UNITED STATES PATENT AND TRADEMARK OFFICE

APPLICATION NO.	FILING DATE	FIRST NAMED INVENTOR	ATTORNEY DOCKET NO.	CONFIRMATION NO.
10/828,503	04/21/2004	Hirohisa Suzuki	AI 338	4304

Office Action Summary

DETAILED ACTION

Figure A

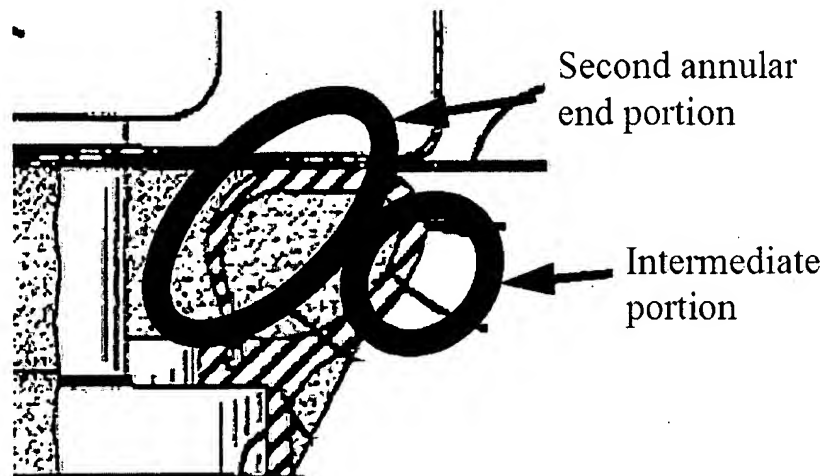
a. A column hole cover 4 interposed between a circumferential portion of an aperture of a column hole formed at an instrument panel 1 for insertion of a steering column 16 therethrough and a steering gear box 2 capable of being displaced in a predetermined direction, the column hole cover comprising: a cylindrical main body 5 extended in the predetermined direction, the main body including a first annular end portion 8 directly or indirectly fixed to the steering gear box, a second annular end portion (see Figure A of this Action), and an intermediate portion (see Figure A of this Action) between the first and second end portions, the second end portion including an annular seal, the intermediate portion including a expandable/contractible portion capable of being elastically expanded or contracted in the predetermined direction, wherein, irrespective of the displacement of the steering gear box, the annular seal is maintained in an

elastic pressure contact against the circumferential portion of the aperture of the instrument panel by a reaction force of the compressed expandable/contractible portion (col 1, lin 39-50) (claim 1.)

8. Applicant's arguments filed 7 December 2006 have been fully considered but they are not persuasive. Applicant argues that the second annular seal is on the second end portion, which is not shown by the reference numeral cited by the Examiner. In the previous Action, the Examiner referred to the nearest numerals, which made the record unclear. The present Action has clarified the rejection (see Figure A above), which the Examiner maintains as proper.
